Price Brothers Farms Unit One

City Plan Commission — December 18, 2025

CASE NUMBER/TYPE:	SUSU25-00101 – Major Combination
CASE MANAGER:	Myrna Aguilar, (915) 212-1584, AguilarMP@elpasotexas.gov
PROPERTY OWNER:	JNC Development, Inc
REPRESENTATIVE:	TRE & Associates, LLC
LOCATION:	East of Patriot Blvd. South of Texas/New Mexico State Line (District 4)
PROPERTY AREA:	36.43 acres
VESTED RIGHTS STATUS:	Not Vested
PARK FEES:	Park Fees Not Required
ZONING DISTRICT(S):	R-5/c (Residential/conditions)

SUMMARY OF RECOMMENDATION: Staff recommends **DENIAL** of Price Brothers Farms Unit One on a Major Combination basis, as the subdivision does not meet the requirements of Section 19.20.030 (B) of the Municipal Code nor the Parks Design and Construction Standards.

Figure A: Proposed plat with surrounding area

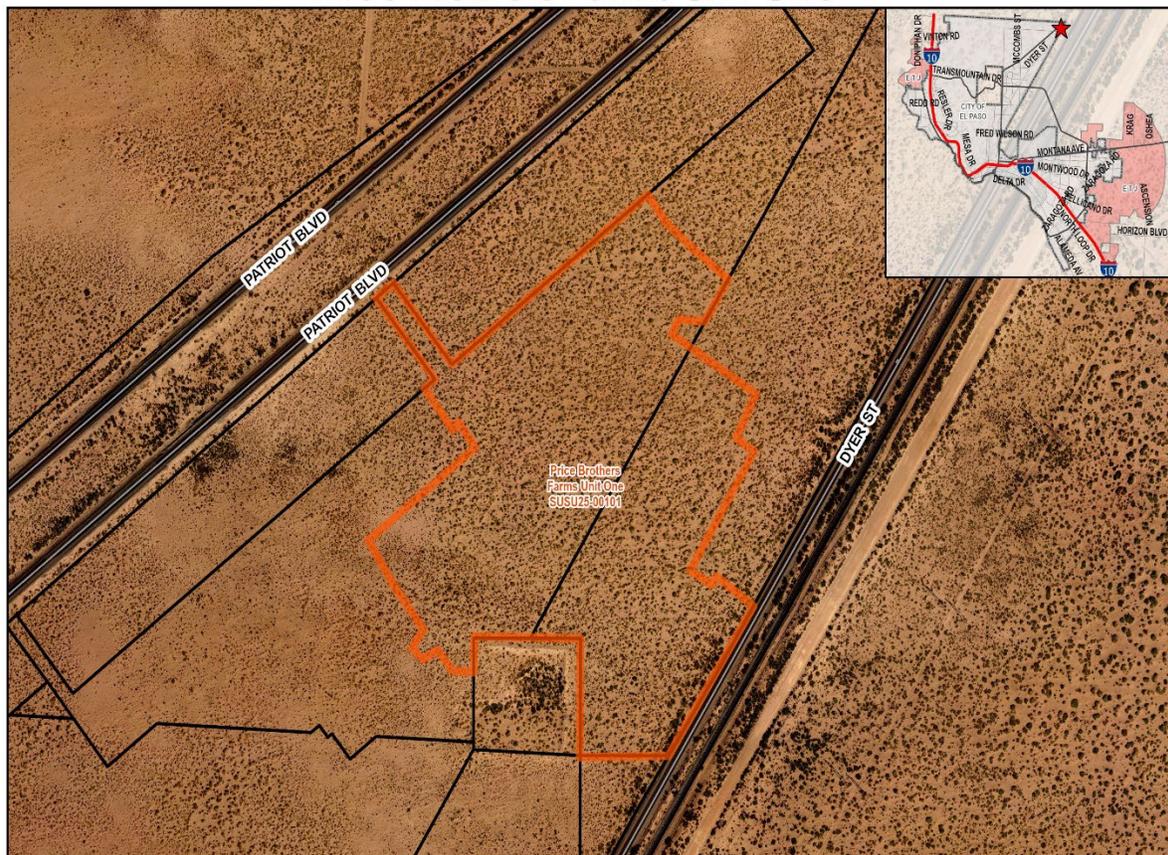
The Parks and Recreation Department has reviewed Price Brothers Farm Unit One subdivision. As per plat, this is a Residential subdivision composed of 173 single dwelling units, and it is proposing to dedicate 1 Park site with a total area of 4.16 Acres. **The Parks department objects to the approval of this subdivision.** Our review has identified several concerns that conflict with the **City’s parkland dedication requirements chapter 19.20 of the municipal code and the Parks Design and Construction Standards:**

1. Remove proposed utility easement on the park site. As per park’s standards: All underground utilities adjacent to a Park shall be installed within street right of way and not within park property and buried at least 4 feet deep. Parks standards can be found at:
<https://www.elpasotexas.gov/assets/Documents/CoEP/Parks/Park-Planning/ParkDesignConstructionStandards.pdf>
2. As per chapter 19.20 parkland conveyed and deeded to the city shall not be subject to reservations of record, encumbrances or easements. Therefore, utility easements won’t be accepted on dedicated parkland.

3. Revise Park acreage. Utility easement acreage does not count as part of the required acreage for parkland dedication.
4. Add a note on the plat specifying who will be maintaining the proposed landscape areas.
5. Proposed landscape areas will not be accepted for maintenance by the Parks and Recreation Department. Please refer to Chapter 19.20.030 B. Types of Parkland that May Be Dedicated.

Until these issues are addressed and the plat is revised to align with chapter 19.20 and the parks design and construction standards; the parks and recreation department cannot support the advancement of this subdivision through the approval process.

ATTACHMENT 2

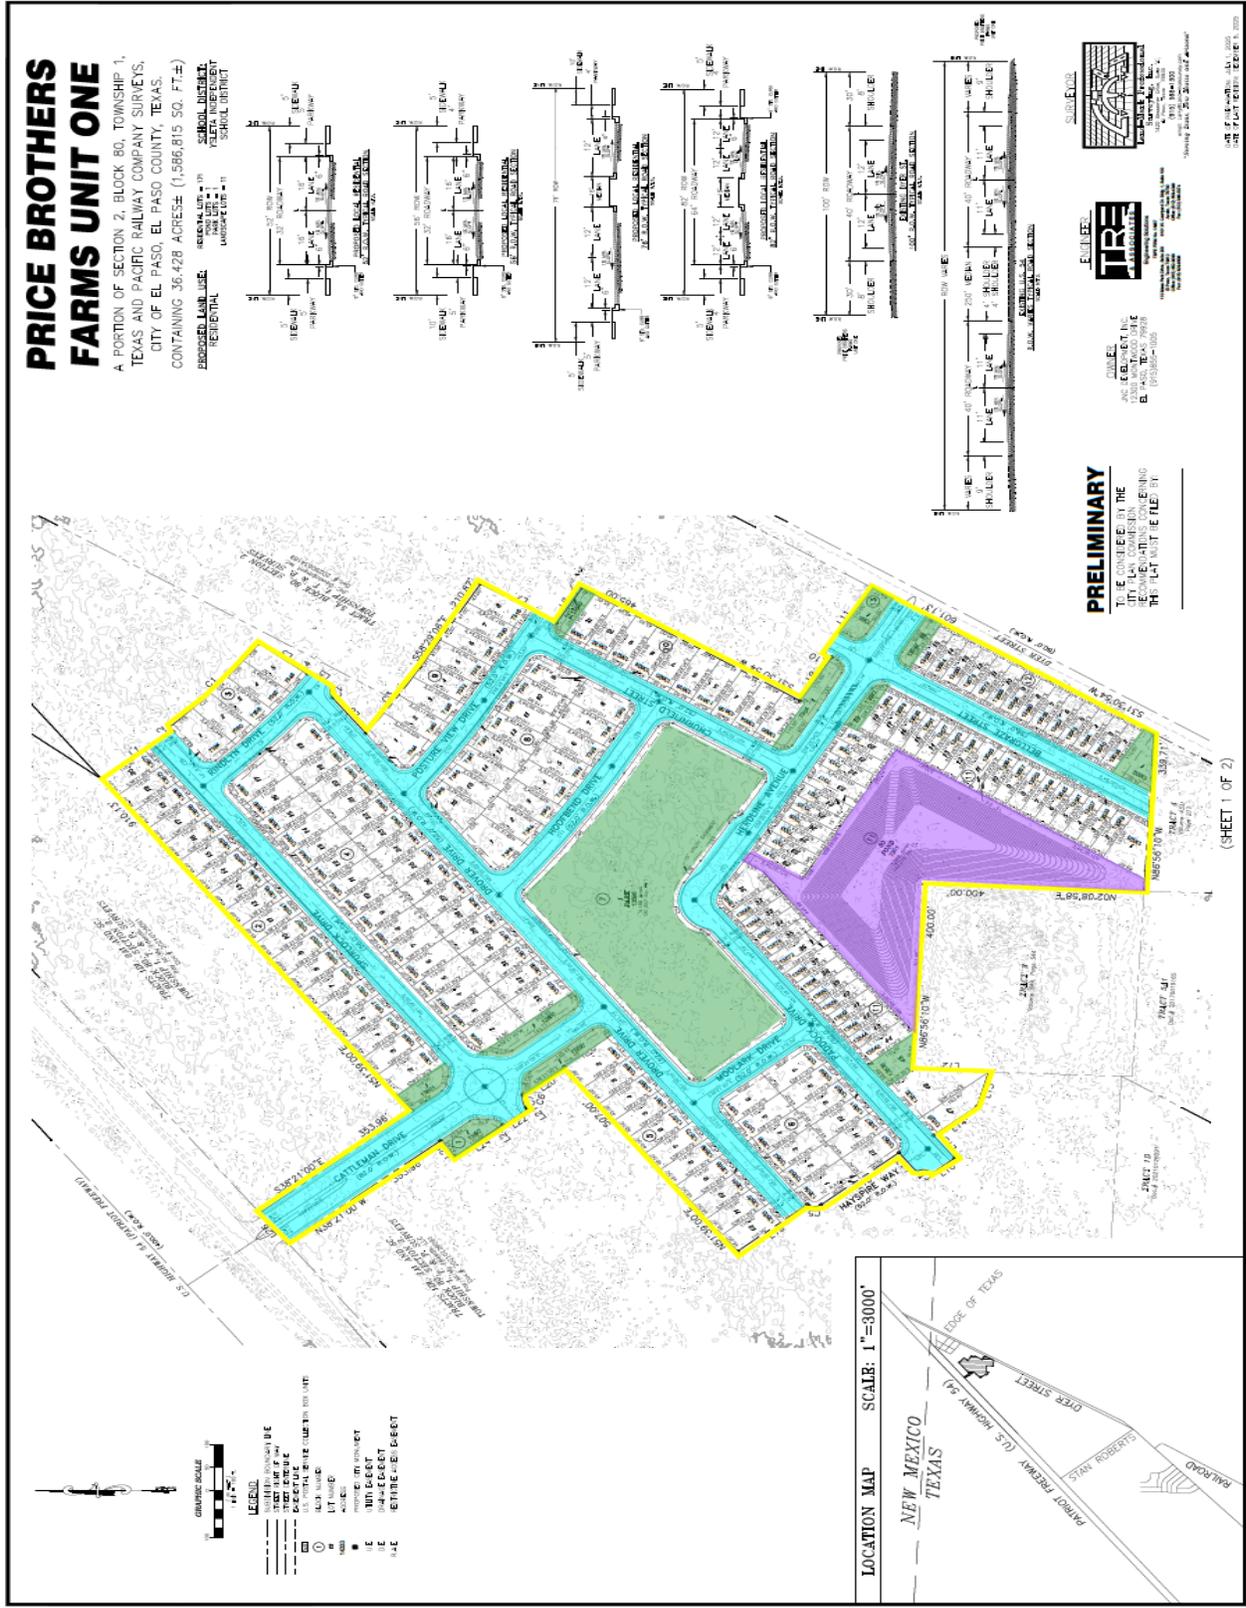
3. Provide and label R.O.W. width on each portion of the street change in the final plat.
4. Provide temporary turn-around easement in all proposed dead-end street in the plat.

5. Provide and label if the park, pond and lineal parks will be private or public in the final plat include information in the dedication statement accordingly.

6. Verify classification of the collector street in “local residential” 82ft R.O.W.
7. Verify 4ft of parkway in 82ft R.O.W.
8. Include name of the streets in each cross sections in the preliminary plat.

10. Indicate a legend in the proposed hatch that showing in the preliminary plat.
11. Verify pond block and lot number
12. Verify lot locations for Lot 22 Block 7, Lot 11 Block 9, Lot 15 Block 10, Lot 33 Block 6, Lot 34 Block 7 in note 12 from Plat notes and restrictions.

13. Define, clarify and label the use of the lots mentioned “to be maintained by City of El Paso” in the plat notes and restrictions.
14. More accurate location in the location map (US Highway 54)

1. Label drainage flow patterns on the preliminary plat. Revision from November had addressed this but they have been removed since then.
2. Annotate the FEMA FIRM panel and flood zone on the Preliminary & Filing Plats.
3. Per the Design Standards for Construction the access ramp for the pond should line up with the access from the right-of-way.
4. At the improvement plan stage, provide protection to the subdivision from all offsite storm water runoff that may have an adverse impact on any improvements and convey the existing watercourse through the subdivision.
5. The proposed ponding area shall have enough capacity to hold the developed runoff for a designated 100-yr. storm event.
